Job No: 2011-09-2206-NEWCOM	Date Applied: 9/9/2011	CBL: 043 - - D - 005 - 001 - - - - -	Phone:
Location of Construction: 468 COMMERCIAL STREET	Owner Name: CITY OF PORTLAND	Owner Address: 389 CONGRESS ST PORTLAND, 04101 ME - MAINE	
Business Name: International Marine Terminal	Contractor Name: REED & REED- JIM WENTWORTH	Contractor Address: 275 RIVER RD, WOOLWICH, ME 04579	Phone: (207) 443-9747 (207) 319-8530
Lessee/Buyer's Name:	Phone:	Permit Type: NEW CONSTRUCTION	Zone: WPDZ
Past Use: International Marine Terminal	Proposed Use: Same: International Marine Terminal- Improvements to the existing site including demolition of unused bldgs, construction of new office bldg, pier expansion	Cost of Work: \$885,000.00	CEO District:
		Fire Dept: <input checked="" type="checkbox"/> Approved w/conditions <input type="checkbox"/> Denied <input type="checkbox"/> N/A	Inspection: Use Group: B Type: 5 ABC-2009
Proposed Project Description: Improvements/ugrades/New office bldg, pier expand		Signature: <i>Catherine</i> 11/23/11	Signature: <i>[Signature]</i> 1/3/12

Project: *International Marine Terminal Improvements (Office Building)*
Special Inspector or Agent: *Daniel Burne* *Becker Structural Engin

INTERIOR WINDOWS

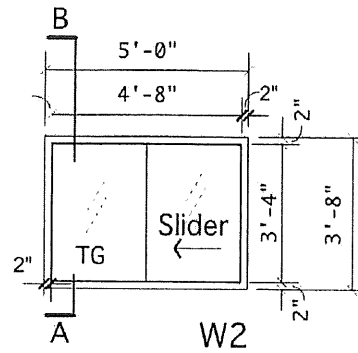
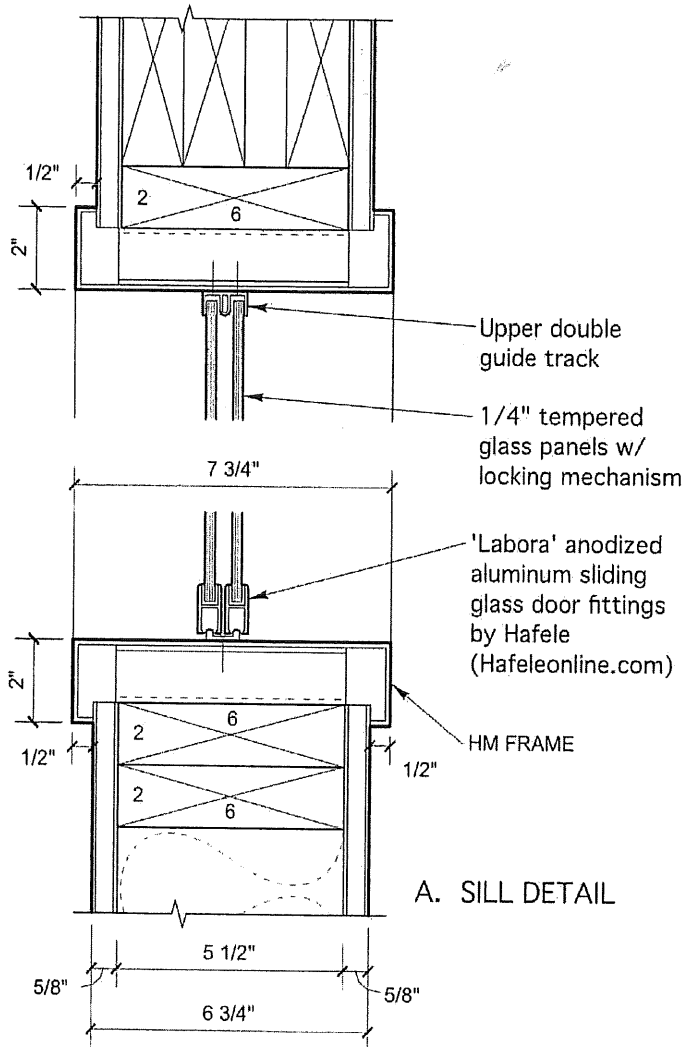
Question: On Sheet A.A1, the Security Office has a type W1 and type W2 window. These windows are not shown on the window schedule or the door and frame schedule. Please clarify.

Response: Interior windows "W1" and "W2" are shown on the Ground Floor Plan on Sheet A.A1 and on interior elevations A/A.A12, 4/A.A13, and 1/A.A13 but they do not appear on the door and frame schedule on Sheet A.A9.

SHELF AND HOOK DETAIL AT ENTRY 107

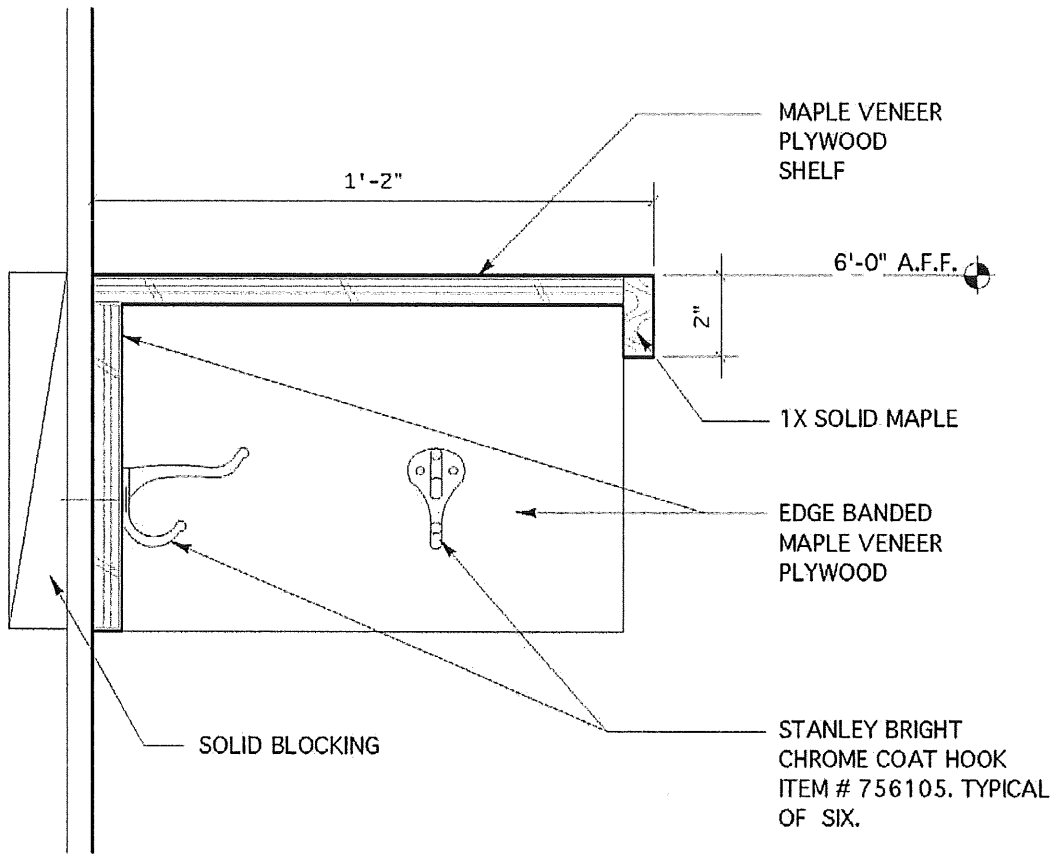
Question: Reference drawing A.A1 in room 107 "Entry" – there are several items shown on the walls (North and West), what is indicated? These items are also shown on the interior elevation 2-2 and 2b on Plan Sheet A.A12.

Response: The items shown on the interior elevations of entry 107 are a built-in bench and a built-in overhead with coat hooks. The bench is described in Detail 4 on Sheet A.A10 and the clear finished wood referenced in the notes refers to maple. A detail of the shelf was not provided. See attached sketch for shelf detail.
